P 535909

**ON-SITE SEWAGE DISPOSAL SYSTEM  
 HOWARD COUNTY HEALTH DEPARTMENT  
 BUREAU OF ENVIRONMENTAL HEALTH**

SUBDIVISION: Scaggsville Knolls LOT NUMBER: Parcel A

ADDRESS: 11229 Melvin Court PROPERTY OWNER: NVR Inc.

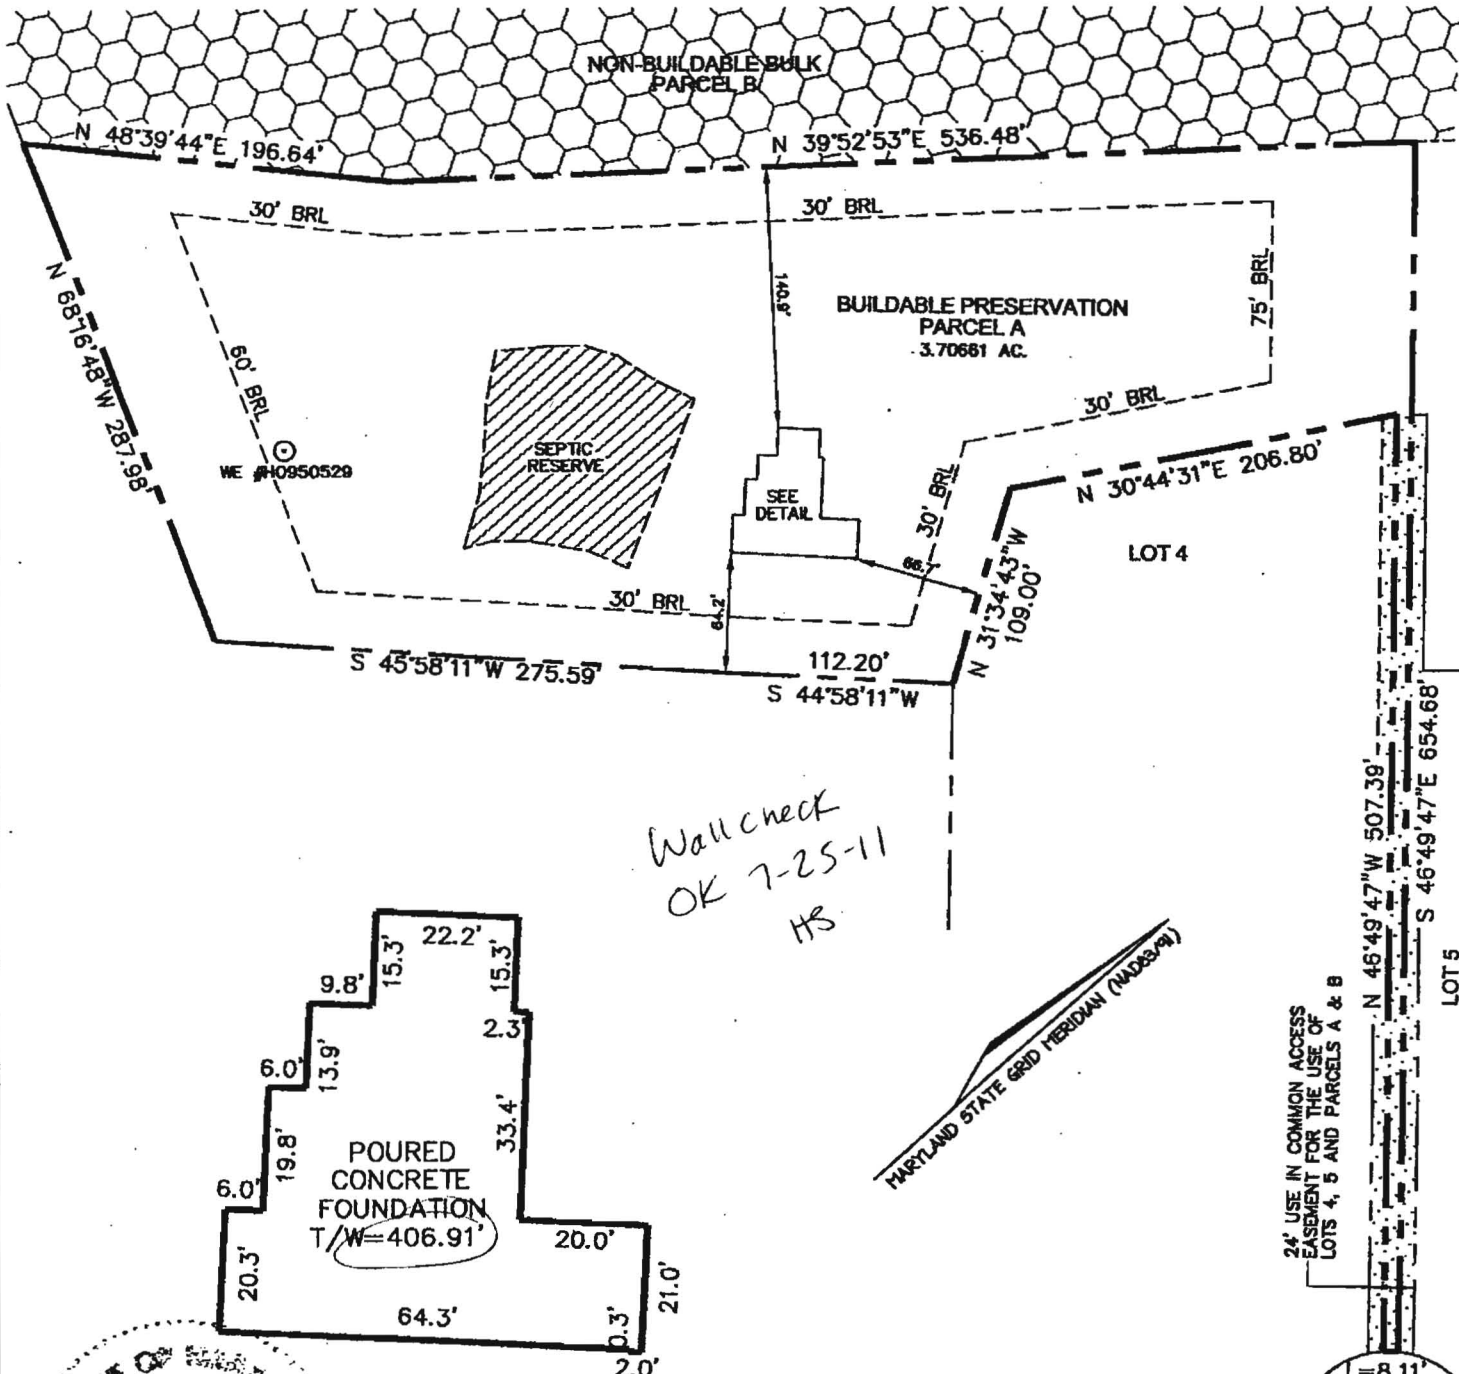
SQUARE FOOTAGE OF HOUSE: Unkwn *2 x 82' trenches*

LINEAR FEET OF TRENCH REQUIRED: 155  
165 *2' wide 4'-8' KW ~82.5*

PRE-CONSTRUCTION  
 7/26/11 Set tank 20' from house. House location has changed. moved further uphill gravity may be possible.

May need to deepen top trench 6"-12". Trenches do start @ high corner of SRA. Install 2x 85' trenches on contour. (KIM)

7/27/11 S.T. set. No trenches complete. (KIM)  
 7/28/11 System complete. OK to back fill (KIM)
